Access Compliance Report

Public Rights-of-Way

(Curb Ramps)

Intersection ID: 14892	Main Street: CLANTON_RD	Cross Street: SARGEANT_DR	Location: W
ADA ID: CF96096ED27E	Ramp Type: PerpDiag	Initial Pass/Fail: Fail	Overall Compliance: No
		Severity Score: 35

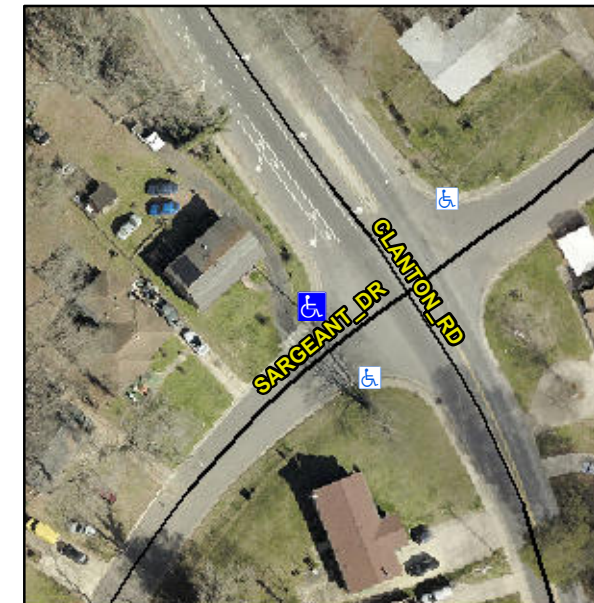
Not Found, R304.5.1, R304.2.2, R304.5.3

Compliance	Description	Data	Compliance	Description	Data
N/A	Ramp Length (in)	50.0	No	Ramp Slope (%)	12.5
No	Ramp Width (in)	42.0	No	Ramp XSlope (%)	3.8
N/A	Flare Type LT	N/A	N/A	Flare Type RT	N/A
N/A	Flare Slope LT (%)	N/A	N/A	Flare Slope RT (%)	N/A
N/A	Flare Traversable LT?	N/A	N/A	Flare Traversable RT?	N/A
N/A	Landing Length (in)	N/A	N/A	DWS Provided?	N/A
N/A	Landing Width (in)	N/A	N/A	DWS Contrast?	N/A
N/A	Landing Slope (%)	N/A	N/A	DWS Length (in)	N/A
N/A	Landing X Slope (%)	N/A	N/A	DWS Full Width?	N/A
N/A	Landing Curb? (Y/N)	N/A	N/A	DWS Offset (in)	N/A
N/A	Shared Landing?	N/A			
N/A	Gutter Ponding?	N/A	N/A	Gutter Slope (%)	N/A
N/A	Gutter Lip Ht (in)	N/A	N/A	Gutter X Slope (%)	N/A
N/A	Painted X Walk1?	No	N/A	Painted X Walk2?	No
	X Walk 1 Direction	To S		X Walk 2 Direction	To E
N/A	X Walk 1 Width (in)	N/A	N/A	X Walk 2 Width (in)	N/A
	X Walk 1 Slope (%)	4.0		X Walk 2 Slope (%)	2.4
	X Walk 1 X Slope (%)	1.2		X Walk 2 X Slope (%)	0.2

Remove & Replace Curb Ramp With Two New Directional Ramps or Equivalent.
